Project	<b>IEEE 802.16 Broadband Wireless Access Working Group</b> < <a href="http://ieee802.org/16">http://ieee802.org/16</a> >	
Title	Figure and updating for interference threshold description	
Date Submitted	<b>2007-05-04</b>	
Source(s)	Wu Xuyong Huawei, Huawei Industry Base, Bantian, Longgang, Shenzhen, China 518129  Avi Freedman Hexagon System Engineering 14 Imber st. Petach Tikva, Israel, 49001	Voice: +86-755-28973547 Fax: <a href="mailto:wuxuyong@huawei.com">wuxuyong@huawei.com</a> ,  <a href="mailto:avif@hexagonltd.com">avif@hexagonltd.com</a>
Re:	IEEE 802.16-07/010: IEEE 802.16 Working Group Letter Ballot Recirc #24a: Announcement (2007-02-01)	
Abstract	AI result according to the group resolution in meeting #48.	
Purpose	To consolidate the 16h draft.	
Notice	This document has been prepared to assist IEEE 802.16. It is offered as a basis for discussion and is not binding on the contributing individual(s) or organization(s). The material in this document is subject to change in form and content after further study. The contributor(s) reserve(s) the right to add, amend or withdraw material contained herein.

## Figure and updating for interference threshold description

Page

Figure 3: the interference grades and the threshold between these grades

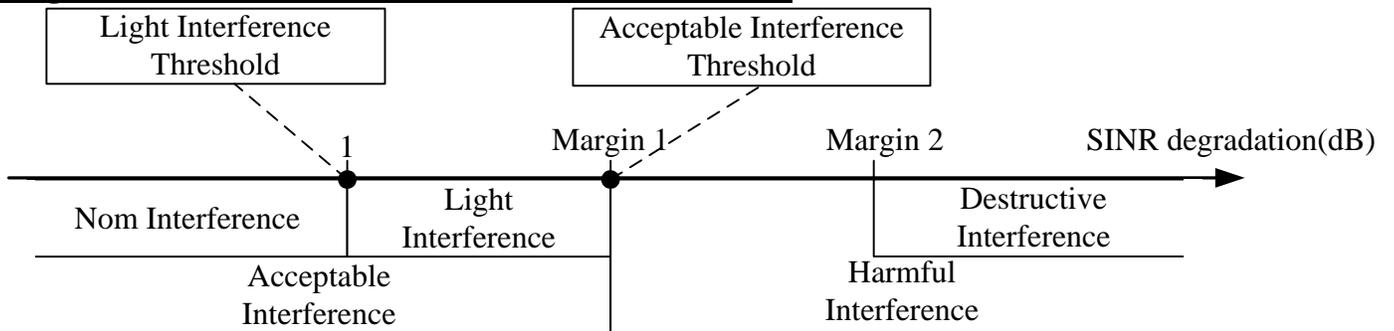
Comment: [Definitions belong in section 3](#)

Suggested Remedy: [Move interference and threshold definitions to section 3.](#)

Reply by Wu Xuyong: [May we put a figure to summarize these interference and threshold here \(before "In addition to those thresholds,"\) and move the definitions to section3. Seems better for clarification.](#)

1) [Move interference definitions to section 3.](#)

2) [leave the threshold definition and add a figure.](#)

[AI taken by Xuyong to work with Avi to provide the figure for interference threshold.](#)
